**AGENDA  
CITY OF ST. CHARLES  
PLANNING & DEVELOPMENT COMMITTEE  
ALD. CLIFF CARRIGNAN – CHAIRMAN**

<b>Title:</b>	Recommend Approval of a Special Use on a Portion of the Property Located at 2900 Dukane Drive for Manufacturing, Heavy (Concrete Batch Plant)
<b>Presenter:</b>	Matthew O'Rourke

**RE:** 2900 Dukane Drive, Special Use for Manufacturing, Heavy (Concrete Batch Plant)

**DATE:** July 3, 2012

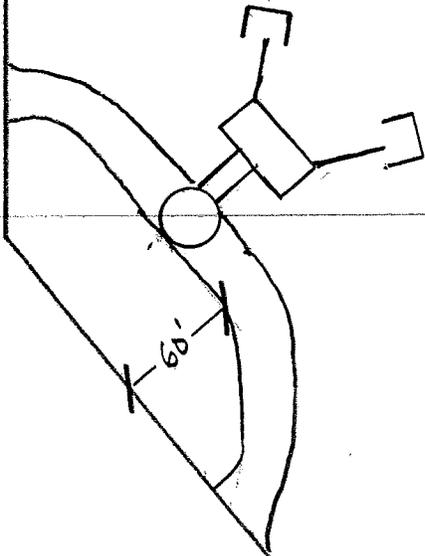
The applicant has submitted a preliminary Stormwater Prevention Pollution Control Plan that Staff is in the process of reviewing. The preliminary plans and description are attached to this report for review. The applicant will need to show the following information on the final plans:

- A to scale site plan of the concrete batch plant and all equipment.
- The location off all stock piled materials and related silt fencing.
- Location of the new water service pipes, related appurtenances, and the sizes of these items.
- Location of the boundary silt fence.
- Location of the inlet filters.
- Location of the build check dam for washout.
- Location of the topsoil stockpile that has been stripped from the site. Details about the temporary seed mix should also be shown on the plans.
- Location of the silt fence around the topsoil stock pile.
- Location of the all Recycling Asphalt Product (RAP) on the site.
- Location of the proposed swale around the border of the site.
- Grading plan demonstrating a positive drainage flow (as stated in the bullet point summary.)
